ENVIRONMENTAL REVIEW TEAM REPORT

RIVER STREET SUBDIVISION
WINDSOR, CONNECTICUT

SEPTEMBER 1980

FIGURE 2.
SIMPLIFIED SITE PLAN

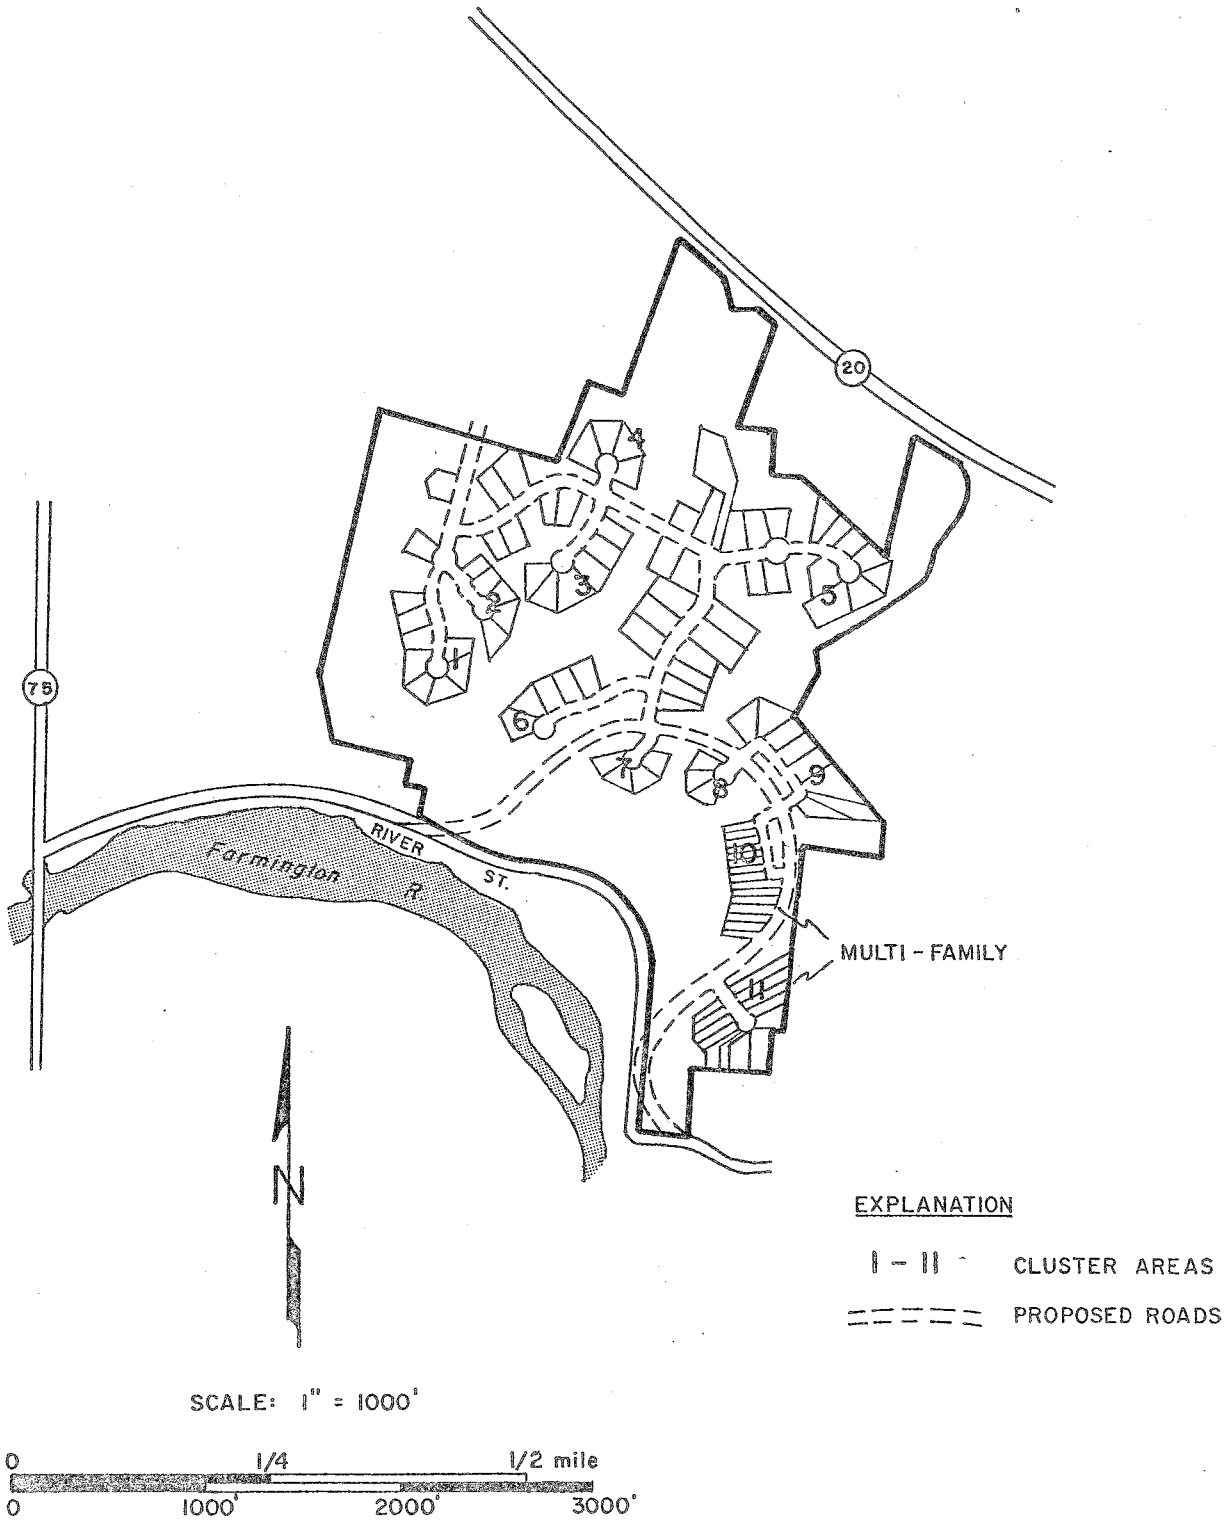
The subdivision plan for the proposed "River Street Subdivision" calls for \pm 120 units. These are to consist of \pm 85 single family homes and \pm 35 condominium units. Access to the project is to be provided by re-routing River Street and constructing a series of cul de sacs and loop roads off River Street (see Figure 2). Access will also be available off Stage Coach Road to the north of the project site. The project is to be serviced by public sewers and water.

The runoff flows on this parcel can generally be divided into three sub-watersheds that empty into the Farmington River. Roads of the subdivision are proposed to cross the brook areas of these watersheds at five different points. When passing across the ravines with at least two of the crossings, substantial fill material will be needed unless road cuts are made on each bank to allow the roads to be installed at a lower elevation. A good example in Windsor of what the proposed ravine crossings will "look like" is provided by the Pioneer Drive crossing of Hollow Brook. It would be desirable to slope the proposed road banks at River Street subdivision more gently than those on Pioneer Drive to avoid erosion problems. Sideslopes of the bank should be at least 2:1 and preferably 3:1 to allow reasonable mowing and maintenance. Seeding of gentle slopes would be more desirable than rip-rapping steeper slopes. If the sideslopes are seeded, a minimum of 4 inches of topsoil should be placed over the fill material. Regardless of the design of the ravine crossings, it will be very important to plan for the effective control of erosion and sedimentation both during and after construction.

The proposed re-routing of River Street will pass over floodplain and inland-wetland soils. The proposed re-routing will entail three brook crossings within the floodplain area. When crossing the brooks, it will be important to install culverts under the roads at the brook crossings that are properly sized to handle storm water runoff during peak storms assuming full development of the total watershed acreage.

FIGURE 4.

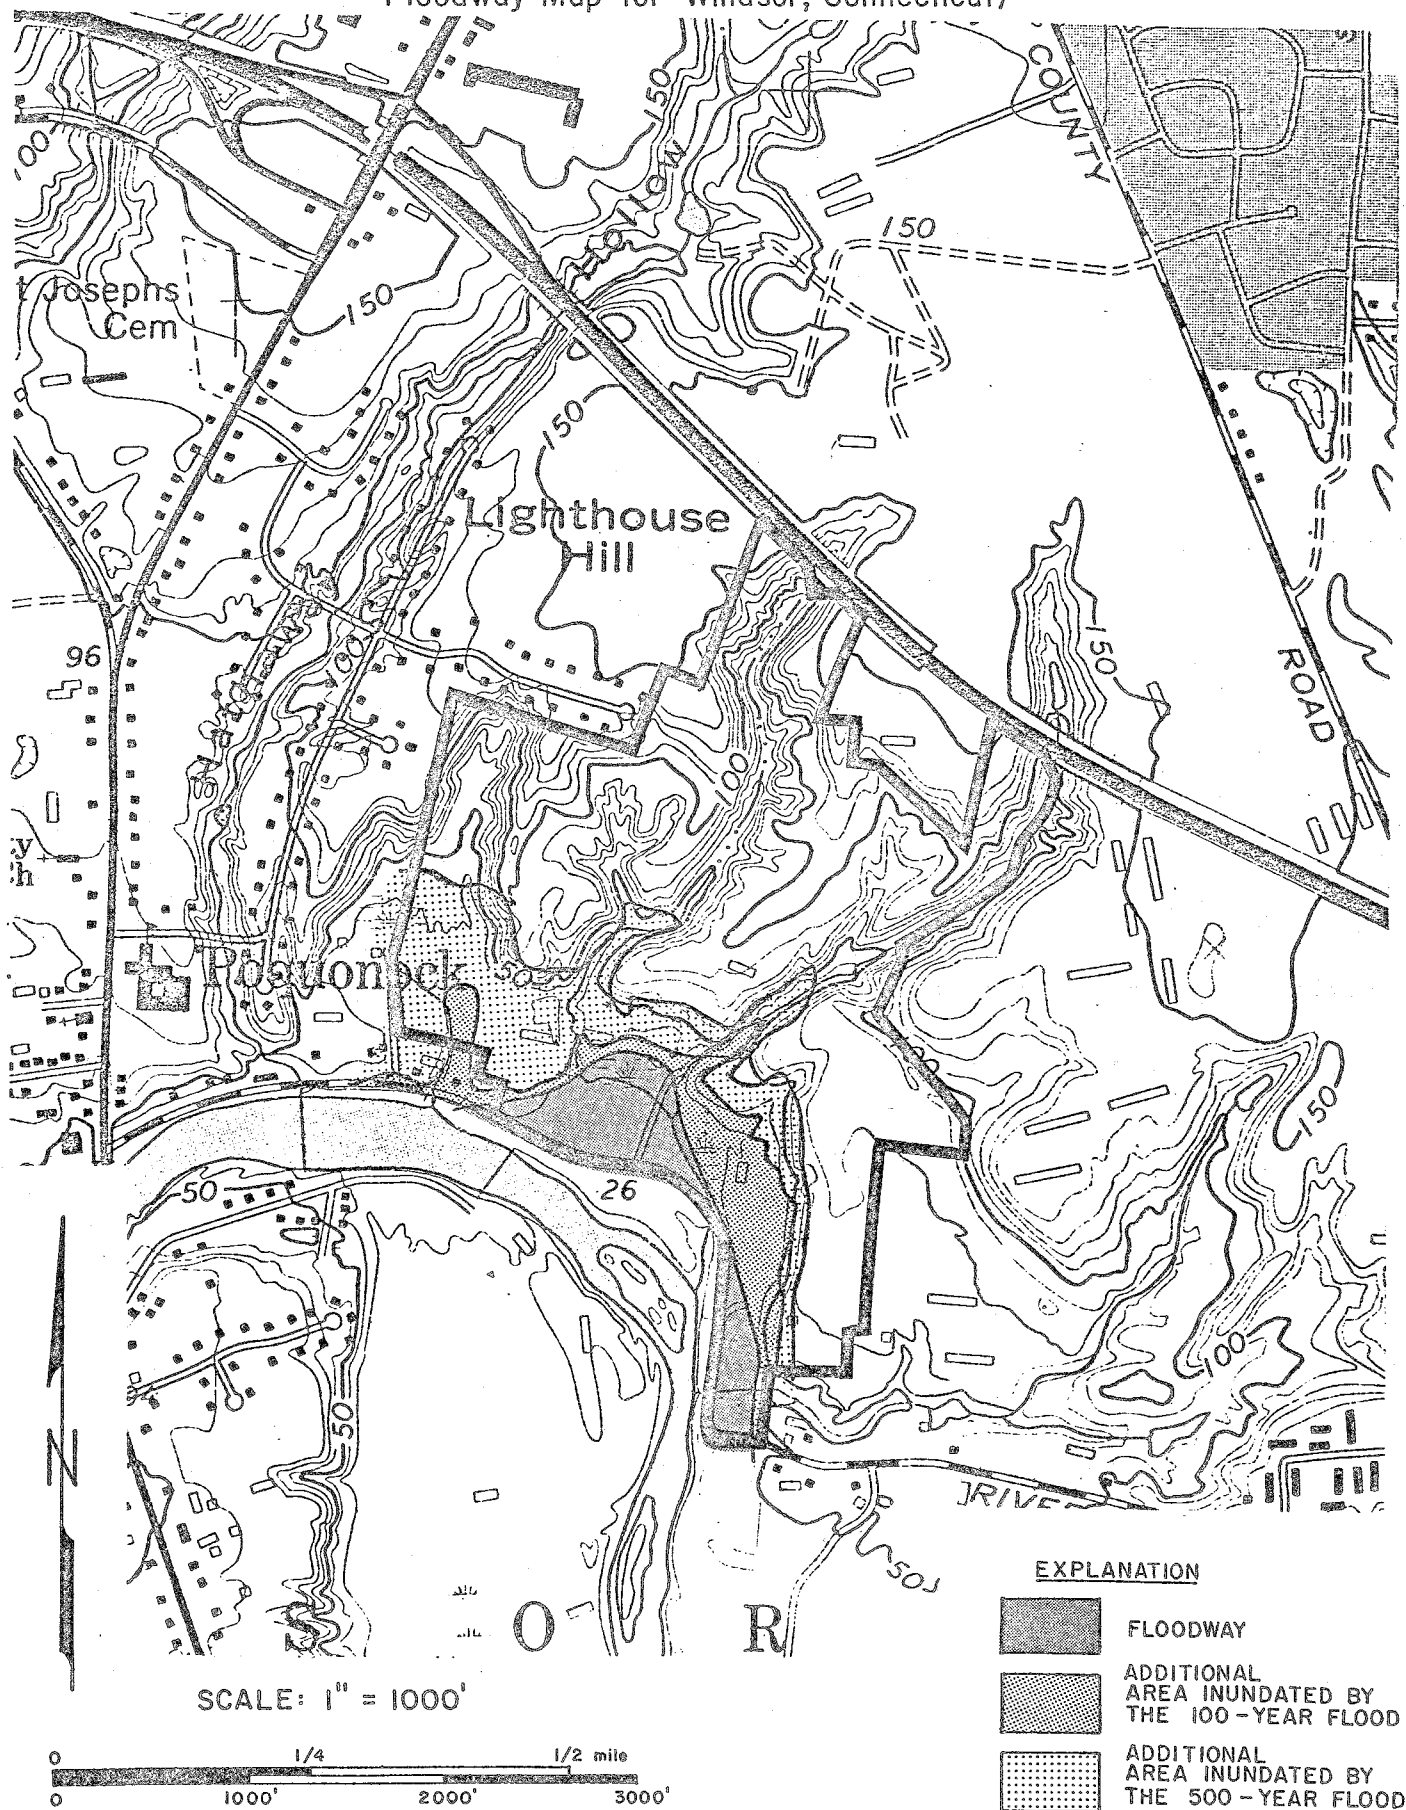
The site lies immediately north of, and is entirely within the watershed of, Farmington River. Intermittent streams flow through a system of deep, precipitous ravines which originate just north of the site. Much of the present frontage of the property on River Street lies within the floodplain of Farmington River and, according to local residents, is flooded every year. The U. S. Department of Housing and Urban Development has issued Flood Boundary and Floodway Maps for the Town of Windsor; a flood boundary map of the River Street site, adapted from the HUD studies, is included as Figure 4 of this report. The developers plan to re-route River Street so that it would no longer be affected by the more frequent floods. Most of the new section of road would lie outside the HUD - designated floodway; however, a small portion of road at the southern tip of the site would have to be built on fill within the floodway. The "floodway" is defined as the area of land bordering a stream that must be kept free of encroachment in order to assure that the 100-year flood levels would not be raised significantly (more than one foot). Since the proposed road construction involves a violation of

the floodway concept and since the relocation would be necessary only to provide River Street access to the proposed subdivision (other River Street properties could be reached by alternate, albeit possibly longer, routes during floods), the Town should seriously consider this aspect of the proposal.

FIGURE 5.
VEGETATION TYPE MAP

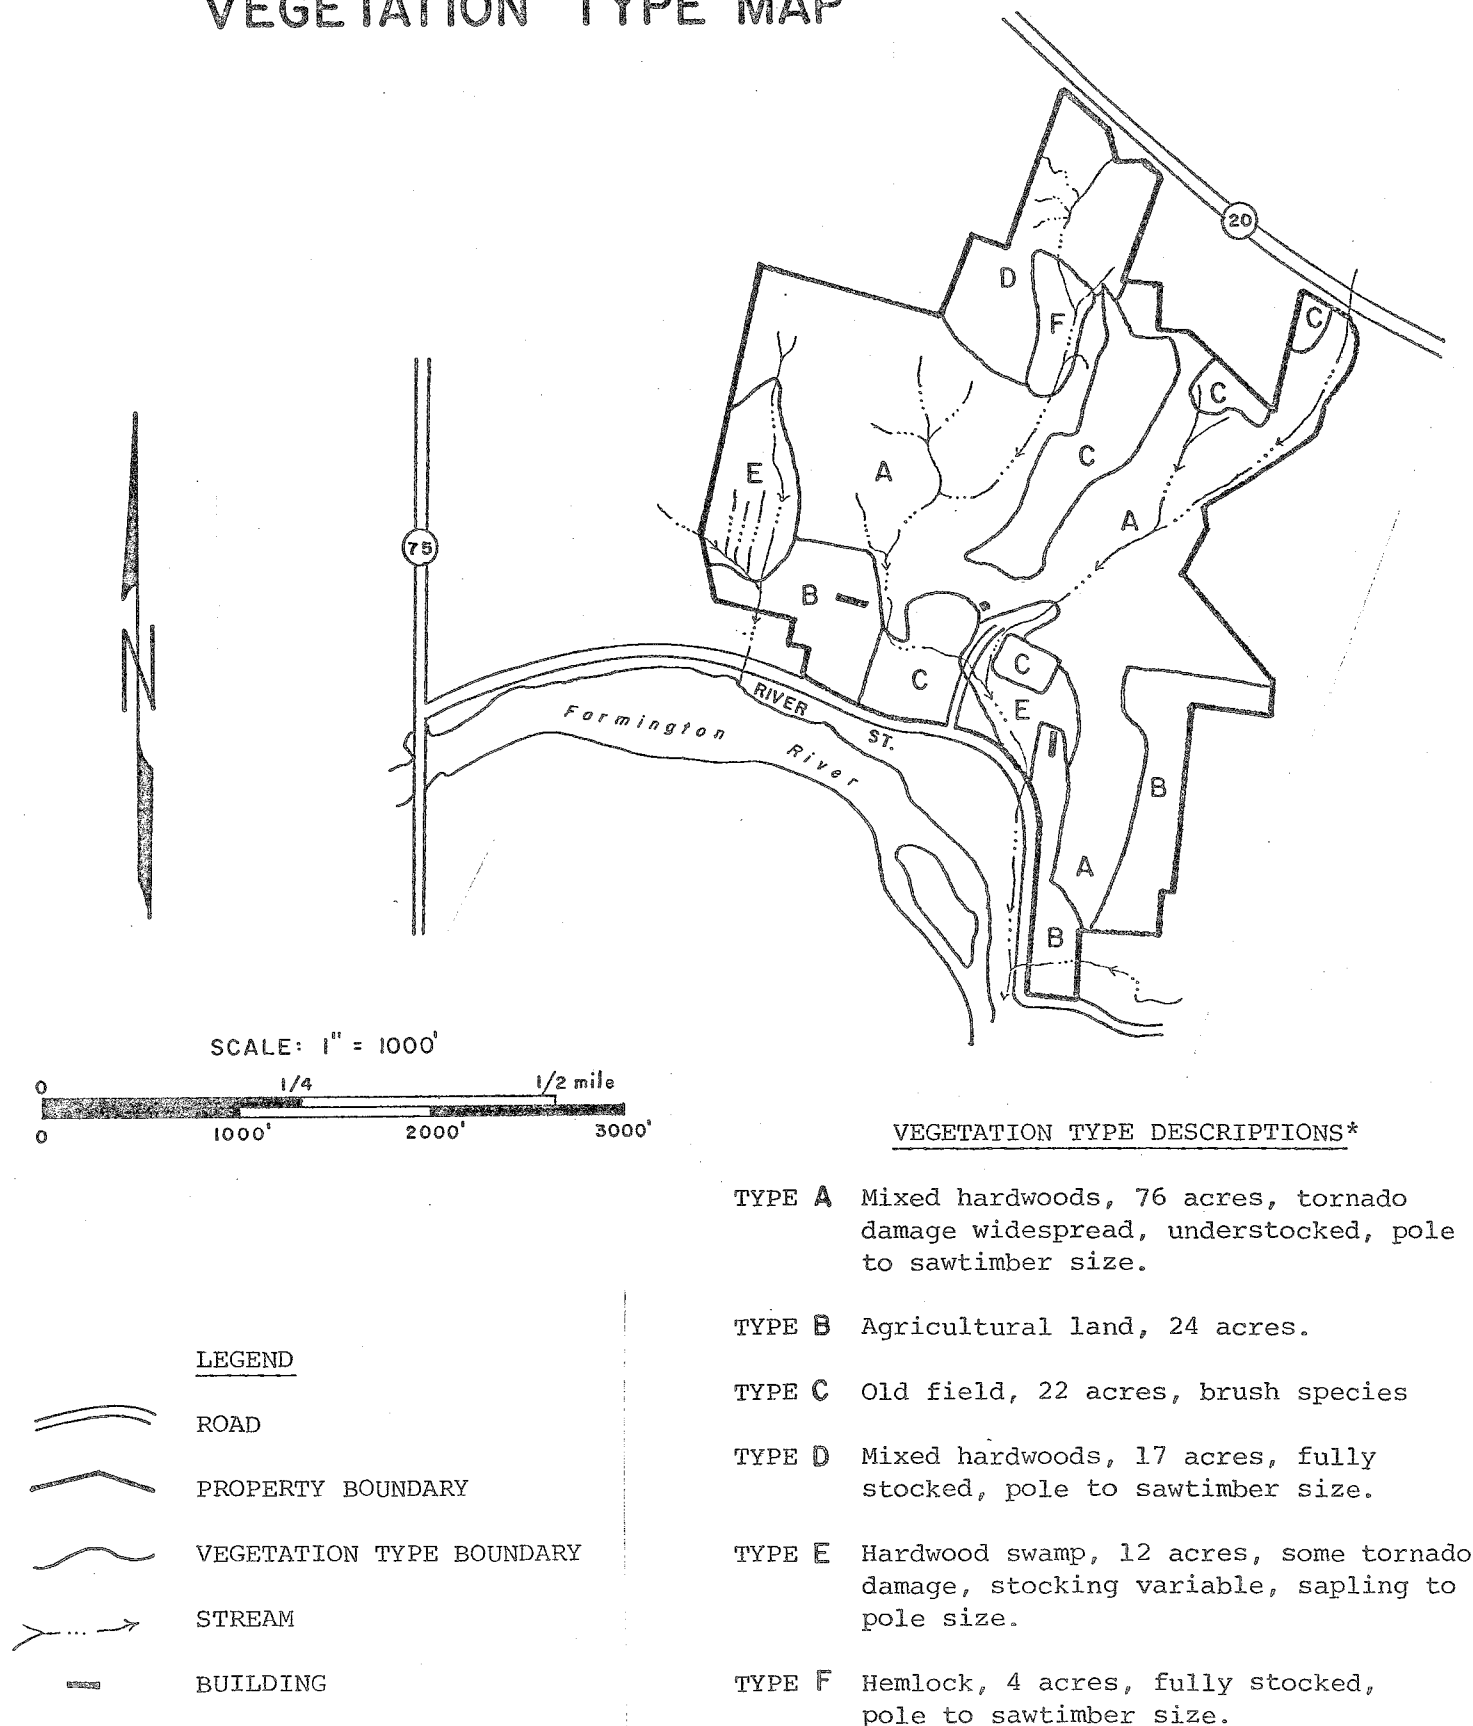
Tornado damage over much of this tract (especially in vegetation type A), has severely reduced the aesthetic value of the majority of the trees. The large, healthy trees in vegetation type A which have not been damaged by the tornado should be retained to the greatest extent possible for their high aesthetic and shade value.

The trees which are to be retained for their aesthetic value should be temporarily but clearly marked so that they can be more easily avoided during construction practices. Special care should be taken near the hemlock trees (vegetation type F) because of their shallow root systems and high susceptibility to sunscald.
